ATTACHMENT I TO IPN-91-040

PROPOSED TECHNICAL SPECIFICATION CHANGES  
RELATED TO  
PRESSURE-TEMPERATURE AND OVERPRESSURE  
PROTECTION SYSTEM LIMITS

NEW YORK POWER AUTHORITY  
INDIAN POINT 3 NUCLEAR POWER PLANT  
DOCKET NO. 50-286  
DPR-64

REACTOR COOLANT SYSTEM COOLDOWN LIMITATIONS - INDIAN POINT 3

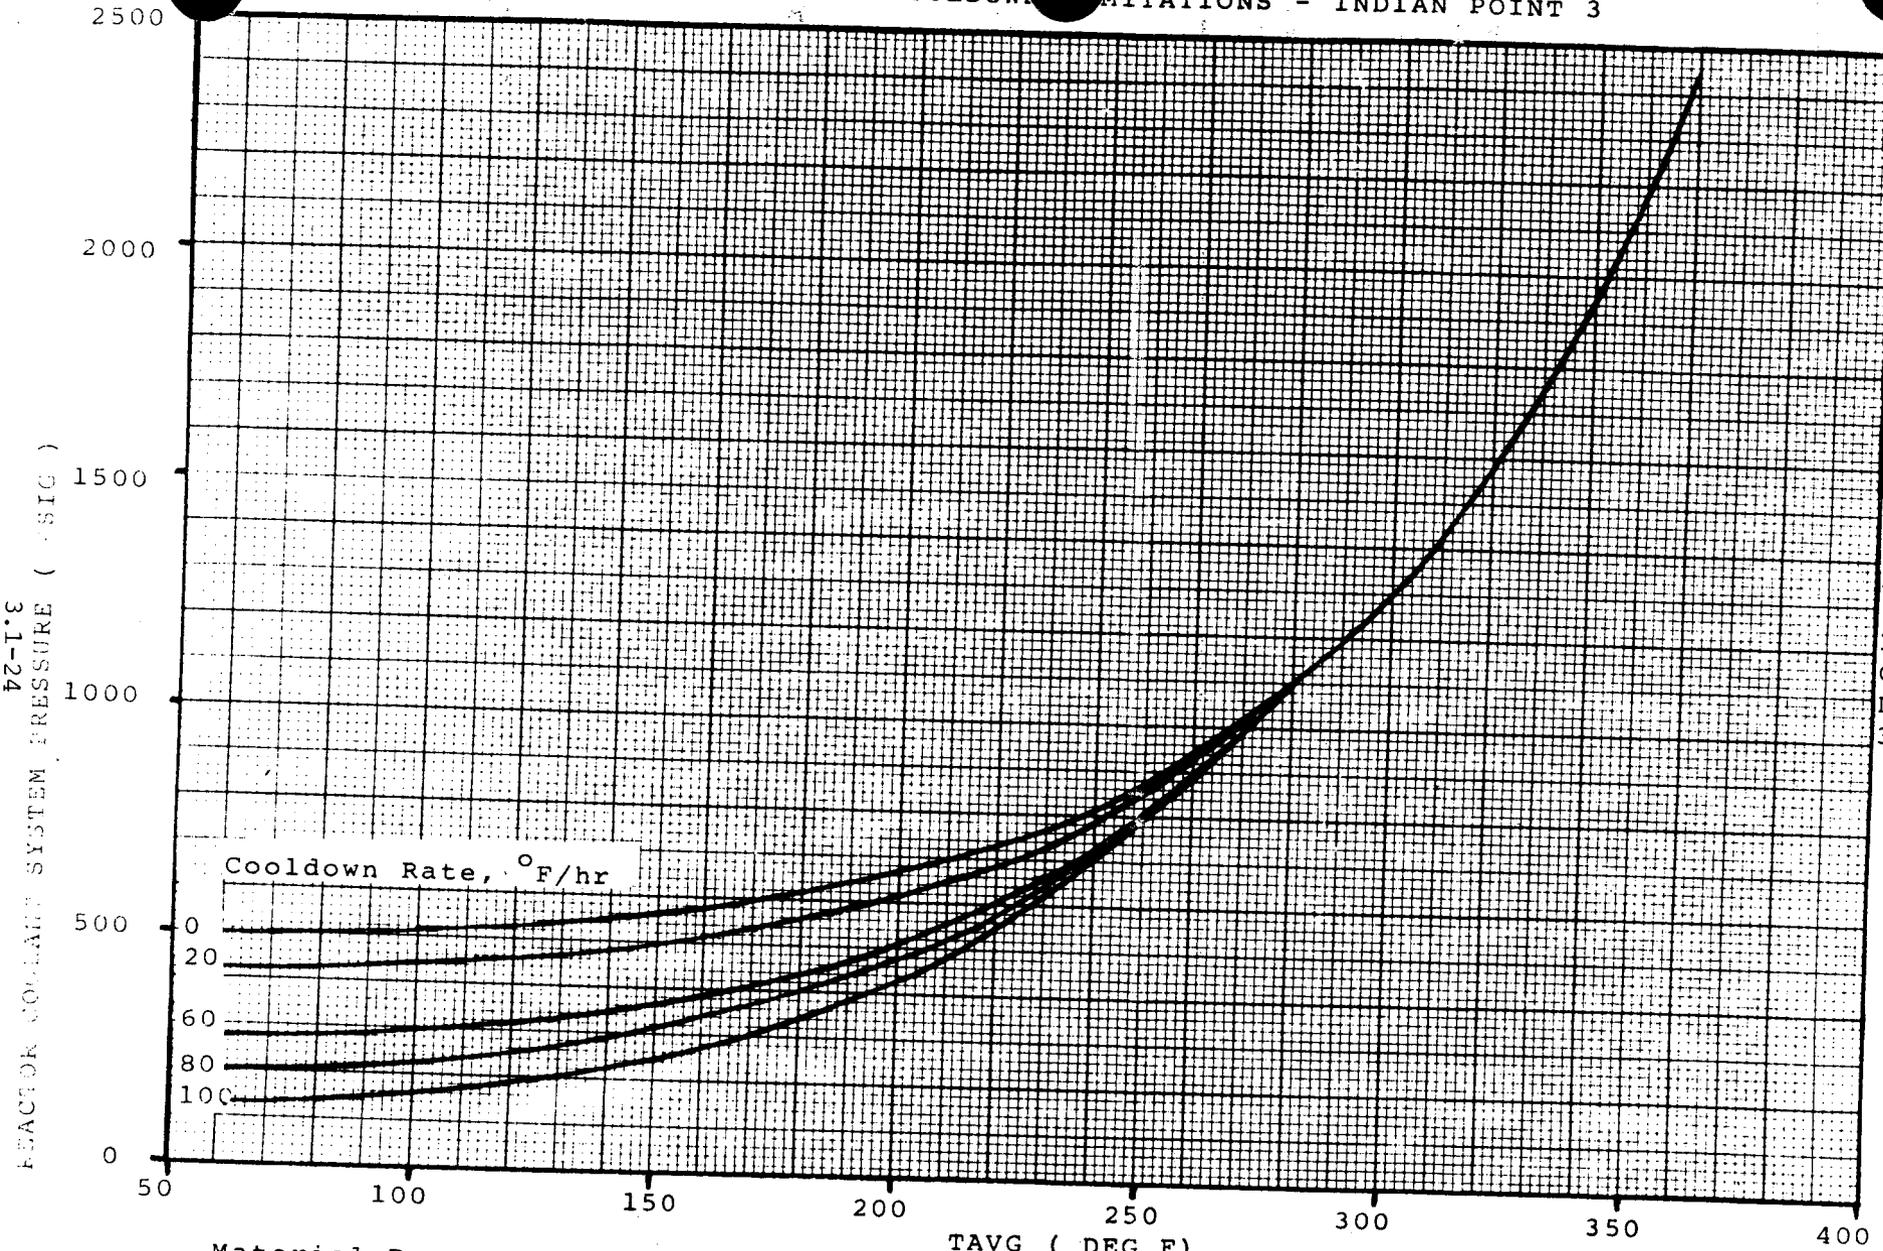
1. The reactor coolant temperature and pressure and system heatup and cooldown rates averaged over one hour (with the exception of the pressurizer) shall be limited in accordance with Figure 3.1-1 and Figure 3.1-2 for the service period up to 11.00 effective full-power years (EFPYs). The heatup and cooldown rates shall not exceed 60°F/hr and 100°F/hr respectively.

Because operation control is on coolant temperature, and cooldown rate may vary during the cooldown transient, the limit curves shown in Figure 3.1-2 represent a composite curve consisting of the more conservative values calculated for steady state and the specific cooling rate shown.

Fig. 4.3-1, PRESSURE/TEMPERATURE LIMITS FOR HYDROSTATIC LEAK TEST

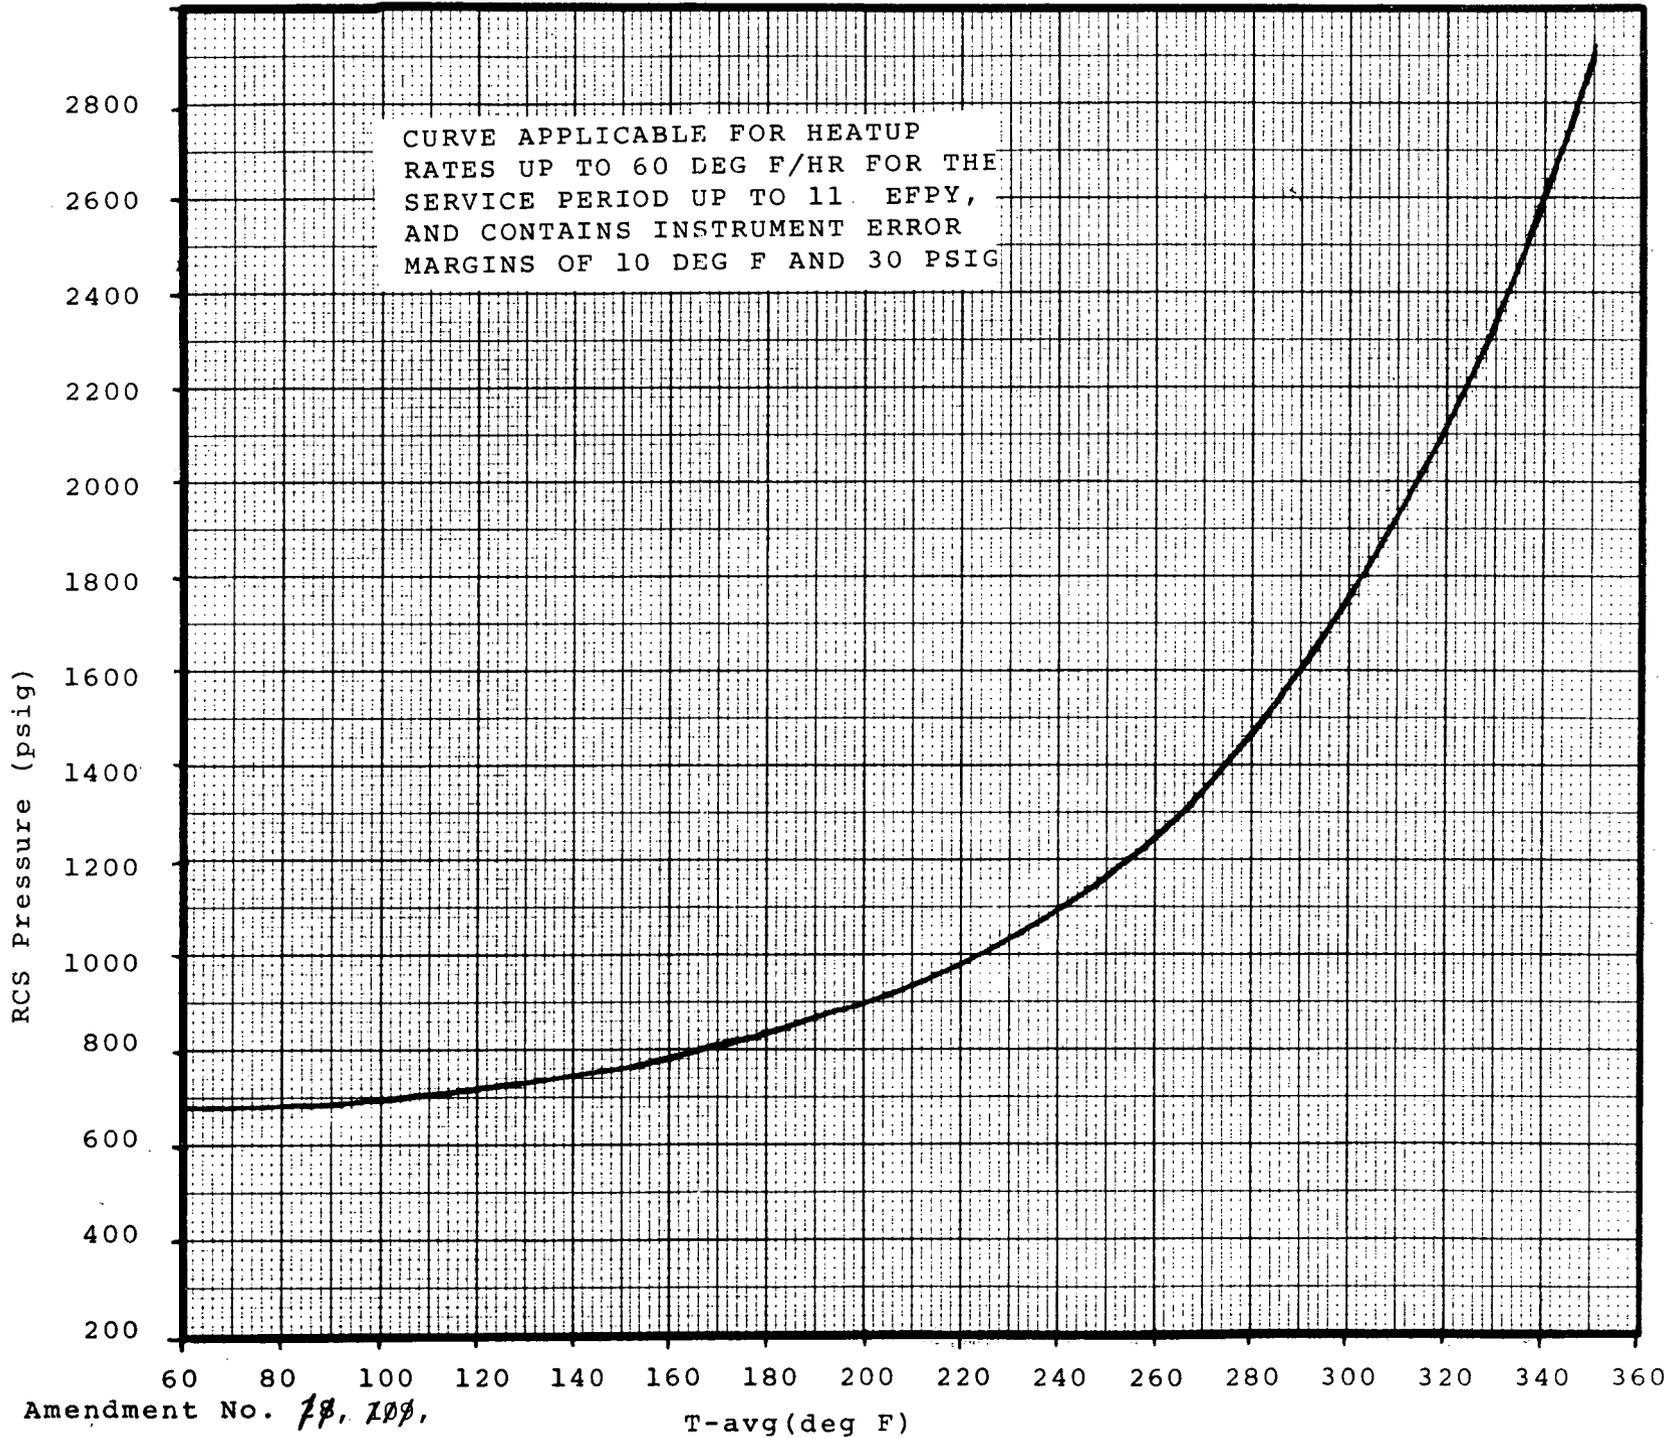
The inservice leak test temperatures are shown on Figure 4.3-1. The temperatures are calculated in accordance with ASME Code Section III, Appendix G. This Code requires that a safety factor of 1.5 times the stress intensity factor caused by pressure be applied to the calculation.

For the first 11.00 effective full power years, it is predicted that the highest  $RT_{NDT}$  in the core region taken at the 1/4 thickness will be 202°F. The temperature determined by methods of ASME Code Section III for 2335 psig is 133°F above this  $RT_{NDT}$  and for 2510 psig (maximum) is 143°F above this  $RT_{NDT}$ . The minimum inservice leak test temperature requirements for periods up to 11.00 effective full power years are shown on Figure 4.3-1<sup>(2)</sup>.

The heatup limits specified on the heatup curve, Figure 4.3-1, must not be exceeded while the reactor coolant system is being heated to the inservice leak test temperature. For cooldown from the leak test temperature, the limitations of Figure 3.1-2 must not be exceeded. Figures 4.3-1 and 3.1-2 are recalculated periodically, using methods discussed in the Basis for Specification 3.1.B and results of surveillance specimens, as covered in Specification 4.2.
